NOTICE OF VIOLATION

INSPECTION REPORT

Electrical Corporation:	Southern California Edison Company				
Report Number:	CAD_SCE_SIS_20240821_0948				
Inspector:	Samuel Isaiah				
WMP Year Inspected:	2023				
Quarterly Data Report (QDR) Referenced: Quarter 4 (Q4)					
Inspection Selection:	Energy Safety viewed the contents of the Q4 QDR and performed an analysis that resulted in the selection of				
	the WMP initiatives and locations referenced in this report.				
Relevant WMP Initiative(s):	8.1.2.1.1 Covered Conductor				
Date of inspection:	August 21, 2024				
City and/or County of Inspection:	Moreno Valley, Riverside County				
Inspection Purpose:	Assess the accuracy of Southern California Edison's QDR data, completeness of its work, compliance with				
	WMP requirements, and compliance with its protocols.

Exhibit A: Photo Log
Structure ID: 2091080E

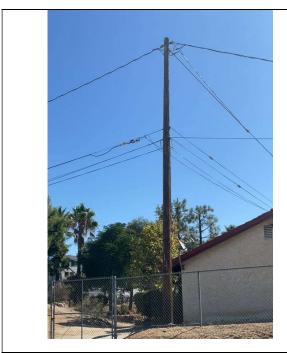
On Pole ID 2091080E, Grid Hardening ID TD2045161-2091080E at 12195 Calle de Jimenez, Moreno Valley, California, 92555, USA, 33.944789, -117.200036, the inspector observed that no covered conductor was present. Additionally, the pole with the identification 2091080E did not support a pole with covered conductor installed via a guy line. The inspector's observation is documented in Violation 1 photographs, which are attachments to this report. Photo numbers Item1GImg1, Item1GImg2, Item1IA1Img1, Item1IA1Img2 depict that no covered conductor was installed at the location.

- 1. Data provided by Southern California Edison Company identified that 2023 WMP Covered Conductor (8.1.2.1.1) work was completed at this location.
- 2. Covered conductor was not installed at the location.

Item1IA1Img1: No covered conductor present

Item1IA1Img2: No covered conductor present
